**Proposed Traffic Management Phase 1
A9 Tomatin South Diversion
A9 Dualling – Tomatin to Moy
Scottish Highlands**

Stage 3 Road Safety Audit

Report No. A9P12-DBA-TTM-ZZZZZ-RP-XX-00008(3)

Appendix B – Location plan of problems identified

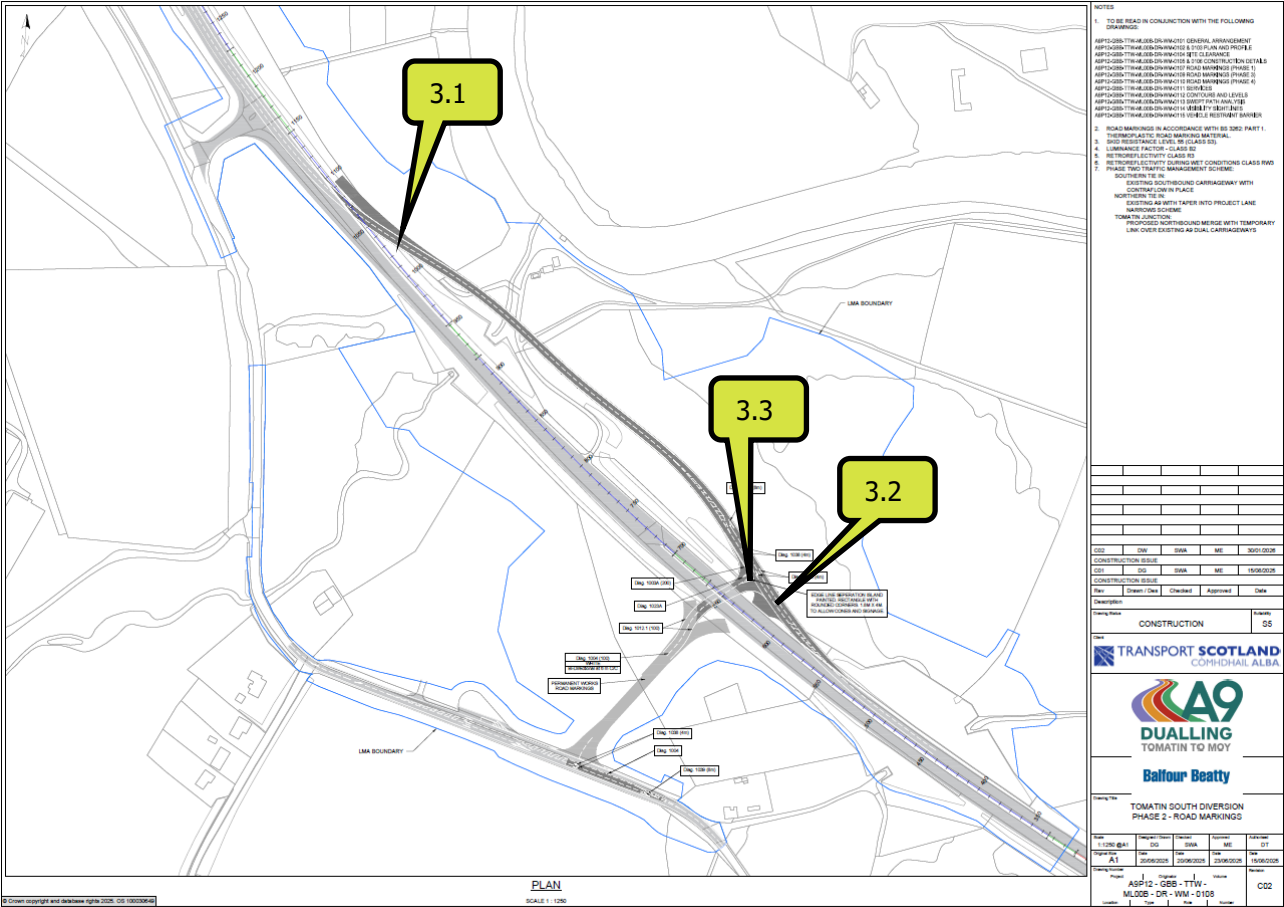
There are three chevron signs (sharp deviation of route) on the offside of the road, which are usually located at, or in advance of a sharp bend, and in this case are pointing to the left. As they are positioned adjacent to a slow right-hand bend, they could confuse motorists, who could brake or manoeuvre suddenly, with the attendant risk of a number of collision types.

The right-turn lane extends as an open lane past the junction. Hatching the lane after the turn point could reduce the risks of northbound motorists mistaking the lane as an overtaking opportunity and of motorists turning right towards Tomatin making excessive forward overturns.

There is an edge line (box) separation island at the end of the centre hatching in the side road, specified on the drawings to allow for cones and signage. Hatching it could reduce the risk of motorists turning right into the side road over the markings and thus of side swipe collisions with vehicles waiting to turn right out of the junction. It should be noted that the position of the right-turn arrow, which is just far enough forward in the lane, could also encourage tight right turns.

It is recommended that the signs are removed.

It is recommended that the lane is hatched after the turn point.

It is recommended that the separation island is hatched.
